PROJECT: Summitin Village 24 Parcels FGH Units 1, 2 and 3 Update

CITY OF LAS VEGAS INTER-OFFICE MEMORANDUM		DATE: September 24, 2020
TO: Land Development Services Department of Building & Safety		FROM: Albert Sung, P.E. Flood Control Project Engineer Department of Public Works
SUBJECT:	Drainage Study for:	
	Summerlin Village 24 Parcels FGH - Units 1, 2 and 3 - Update	
Cross Streets:	Crossbridge Drive & Sky Vista Drive	
File Number:	F:\Depot\DSMemos\DS5210E.doc	
Parcel Number:	164-04-511-001	
Zoning Action:	TMP-76536	
FEMA Flood Zone	YES	NO X
Proposed Storm Drain	YES X	NO
COPIES TO:		
		RCI Engineering
		Lennar Communities Nevada, LLC
		Bart Anderson, P.E., DevCo
		CCPW
		BLM

3rd Submittal: Update to revise some storm drains from RCP to C900 PVC in compliance to recent changes of LVVWD and SNHD criteria

**UPDATE TO THE
TECHNICAL DRAINAGE STUDY
For
SUMMERLIN VILLAGE 24 PARCELS FGH
Units 1, 2 and 3**

DATE: 1-25-20
DRAWING P-1
SHT 20 OF 42
CLV DRAWING NUMBER
CLV PROJECT #

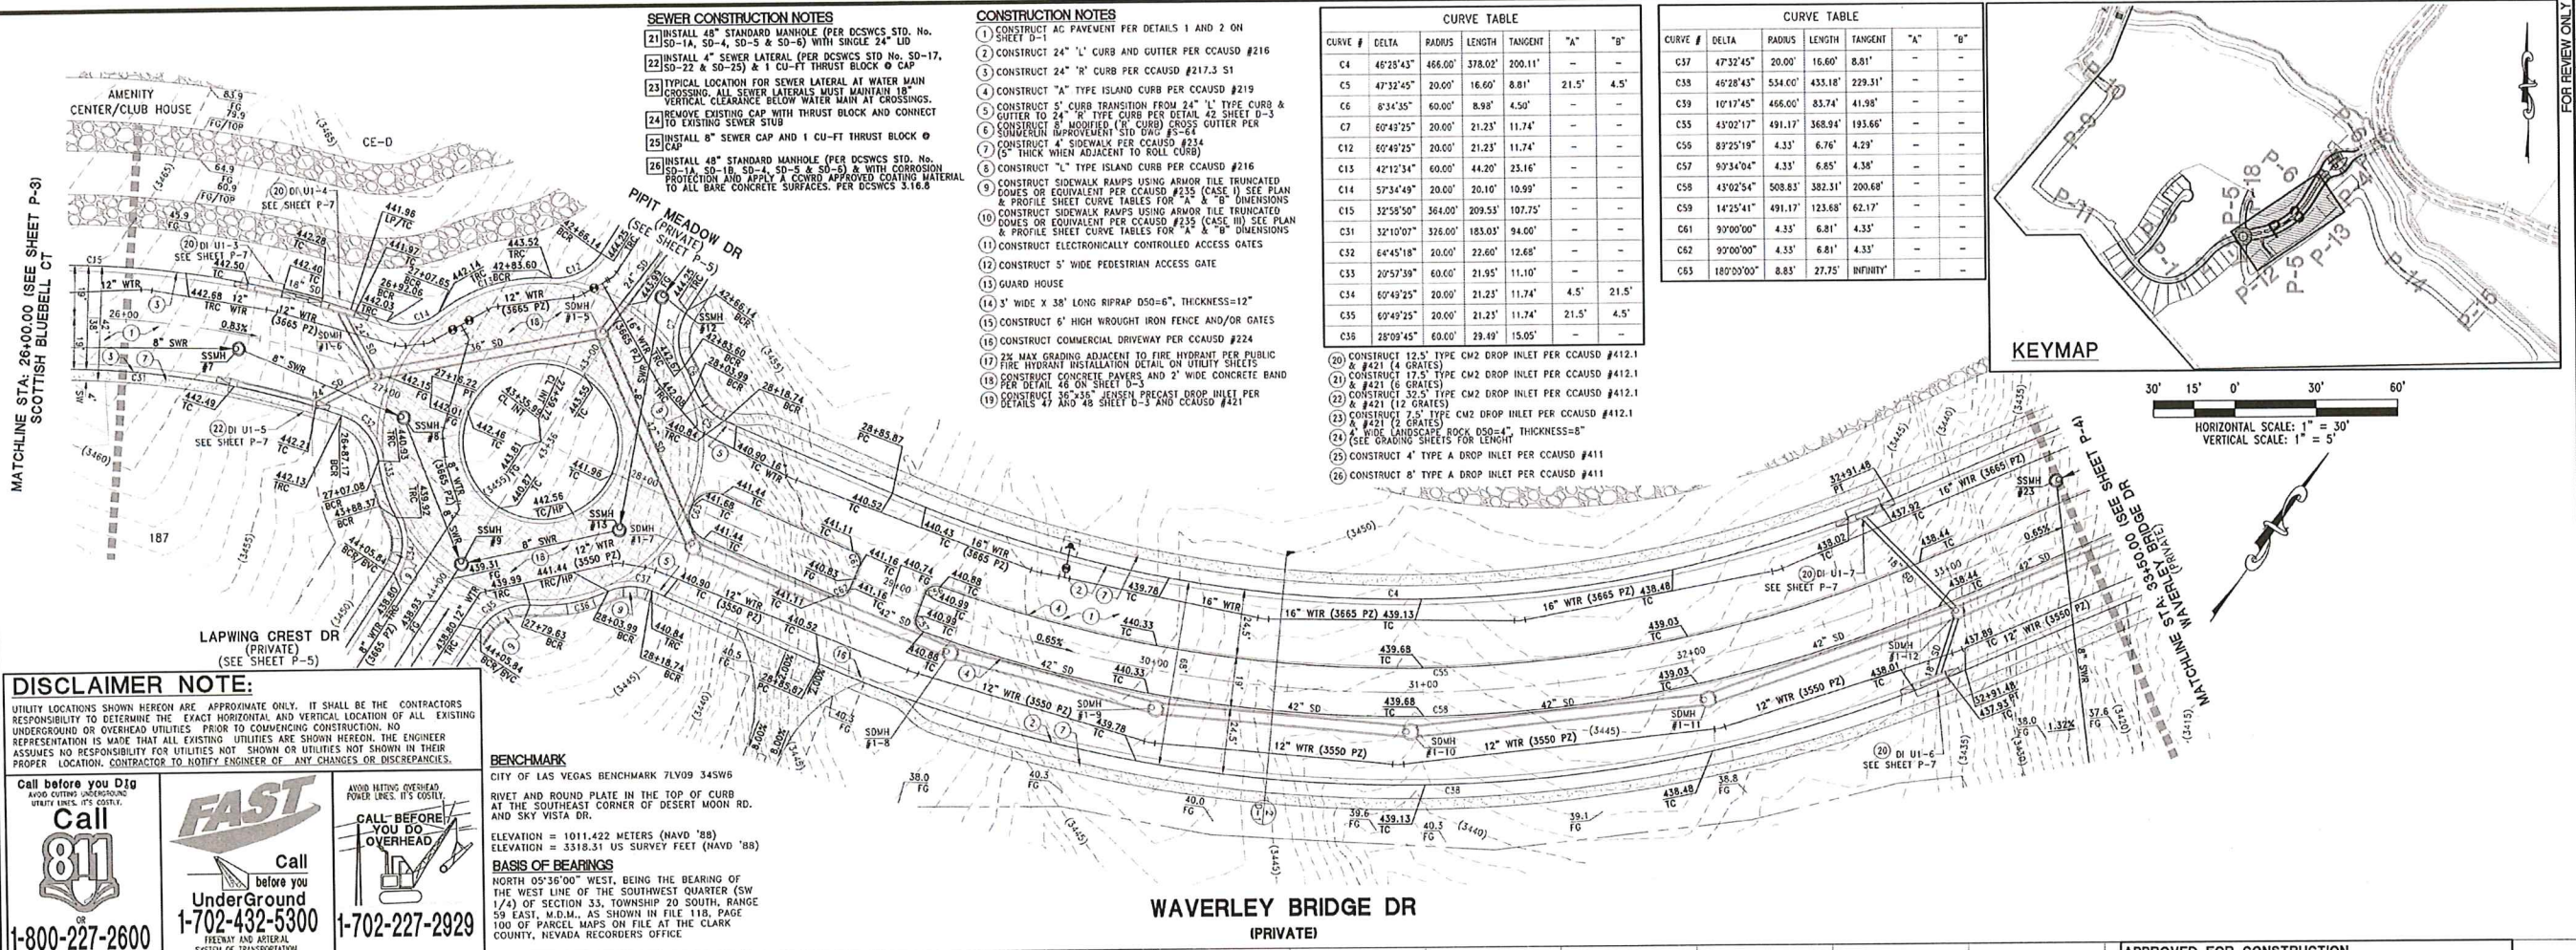
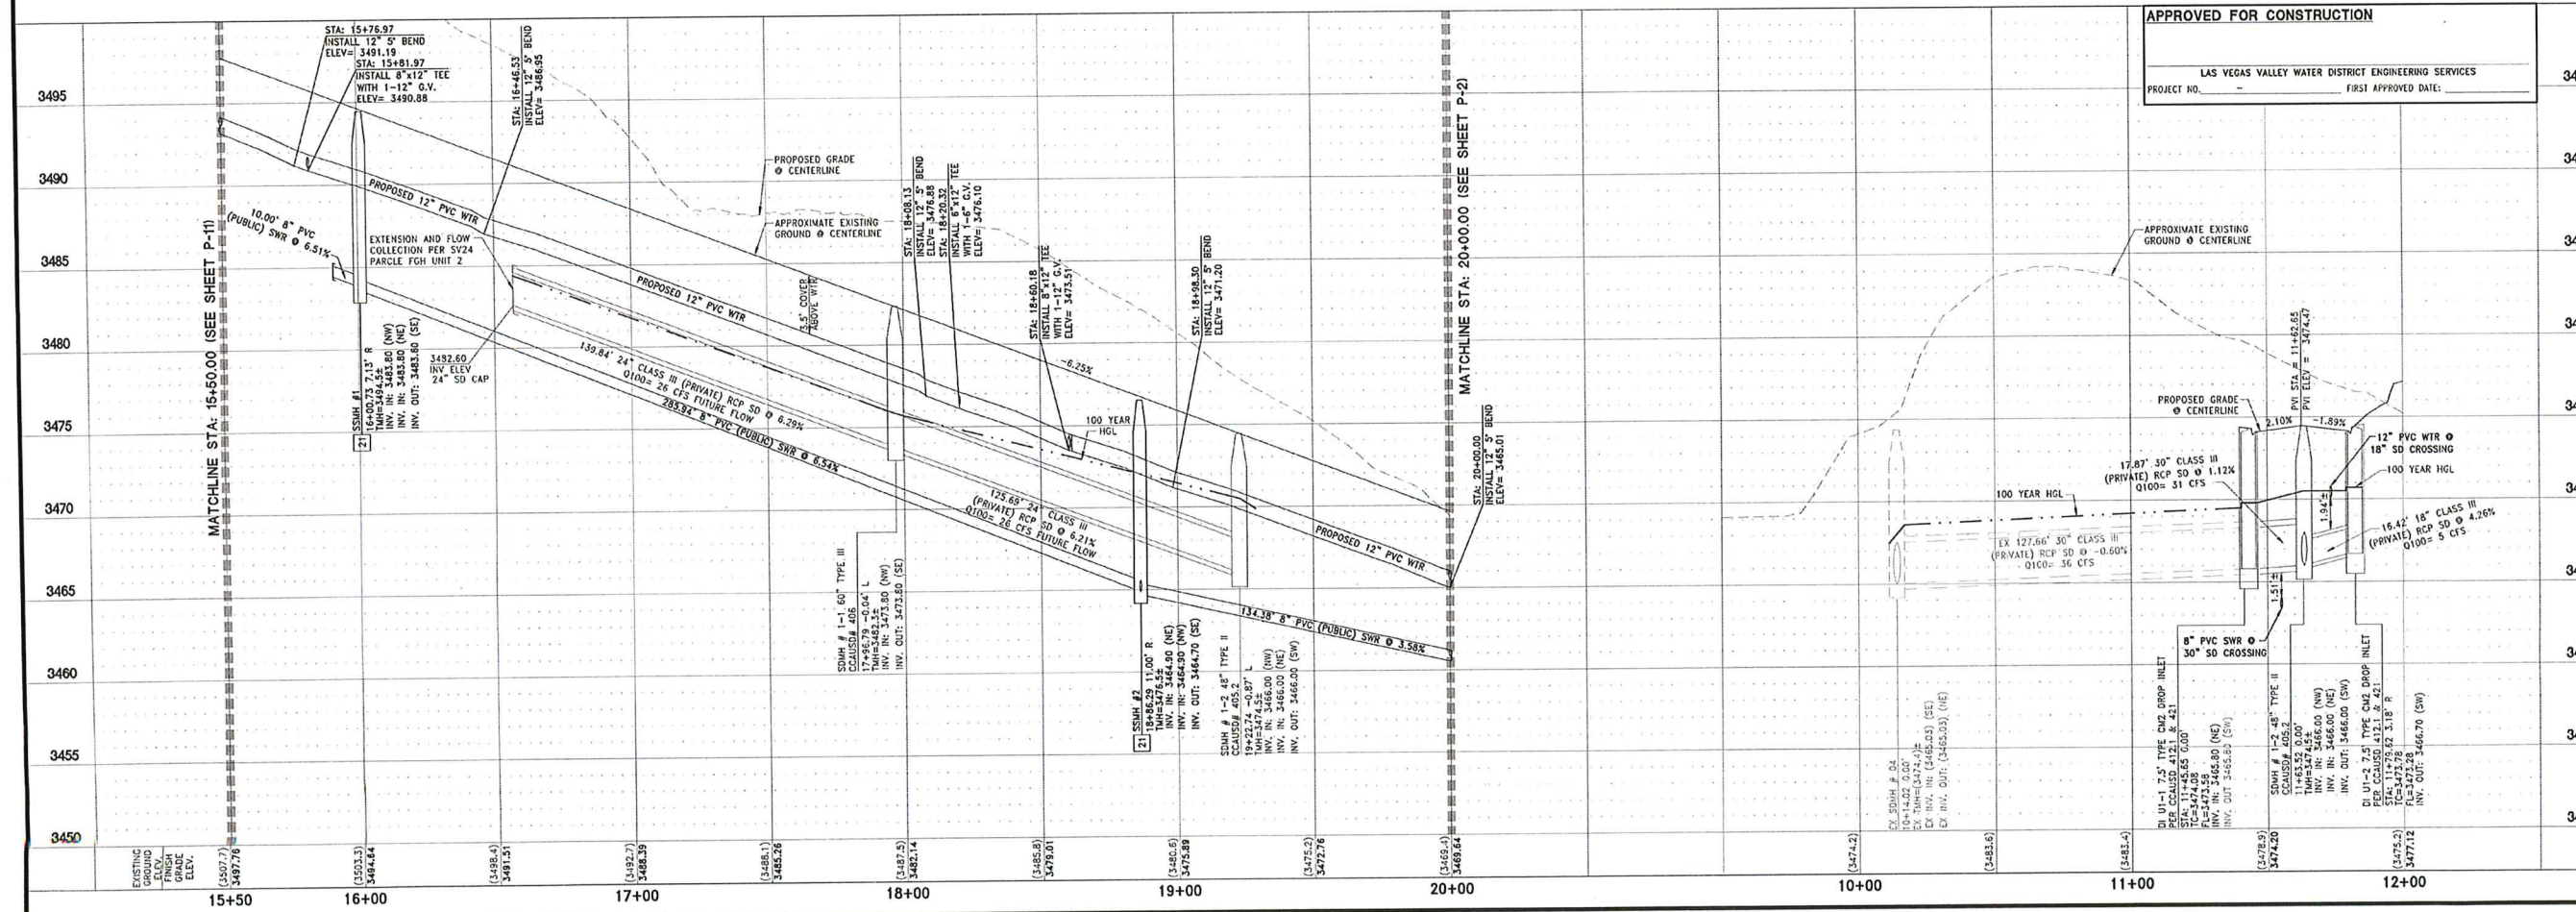
Sheet P-1

DRAWING
P-3
SHEET 22 OF 42
CLV DRAWING NUMBER
CLV PROJECT #

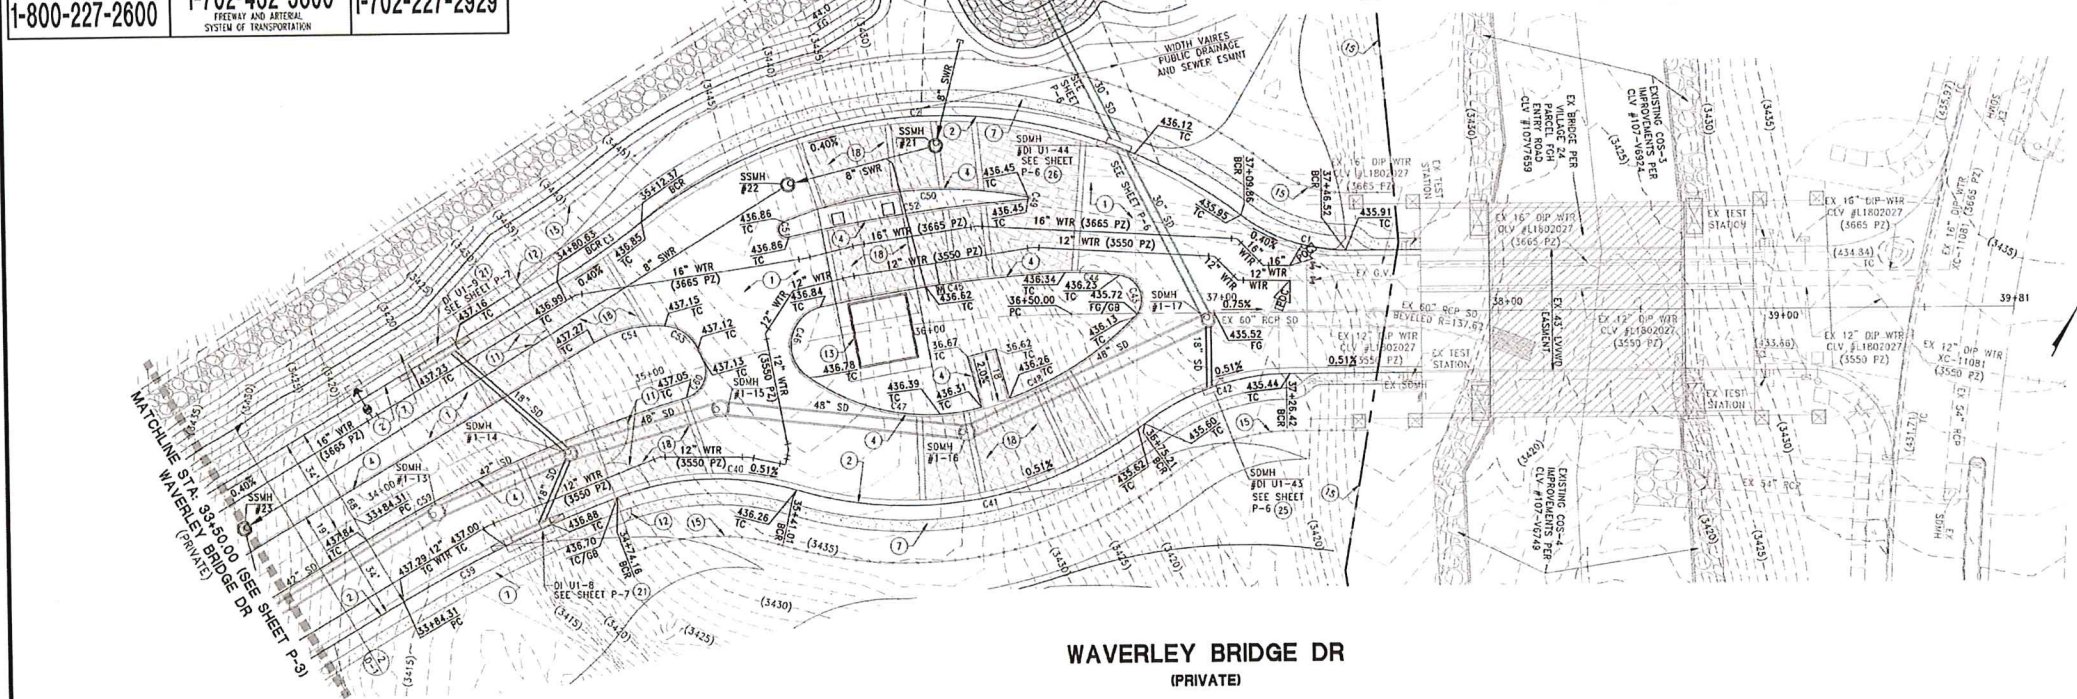
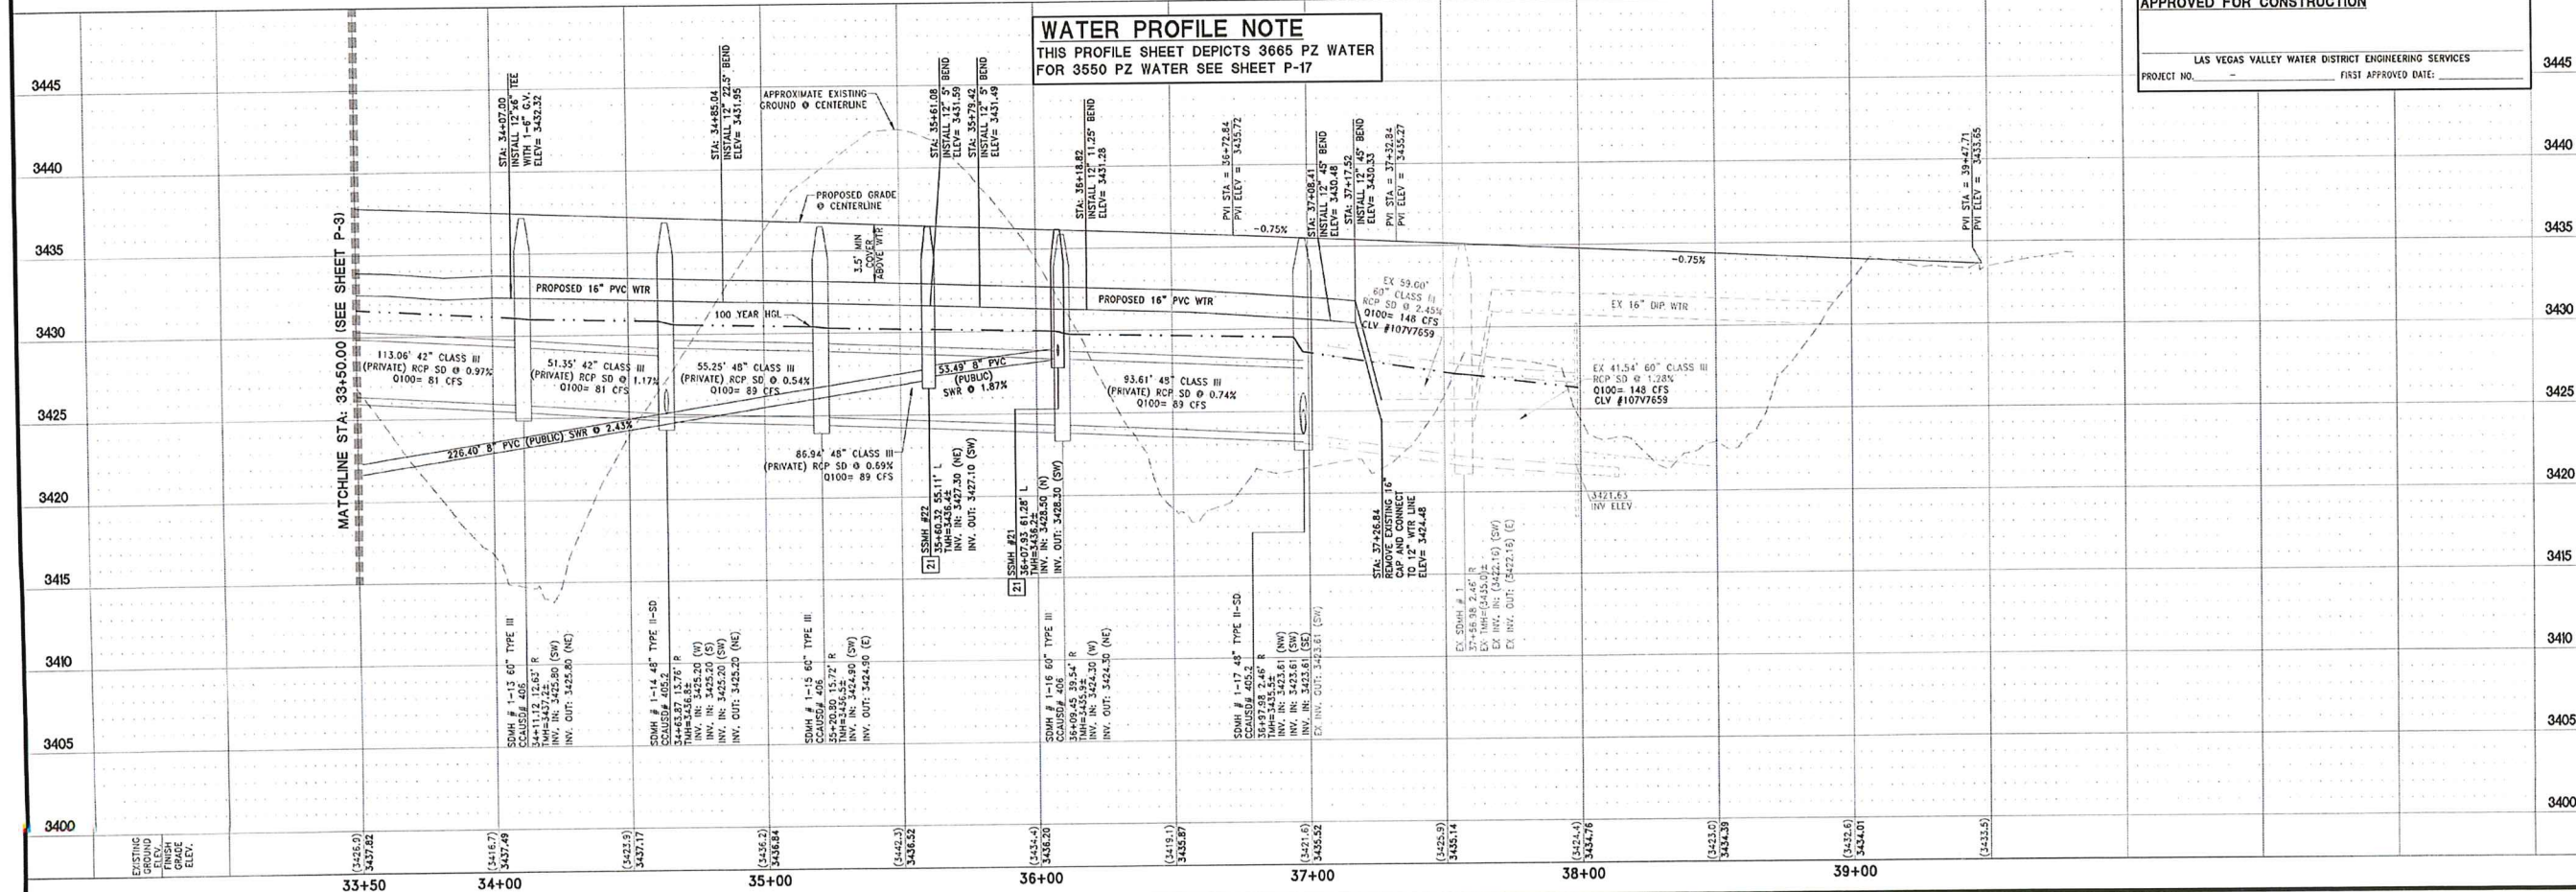
Sheet P-3
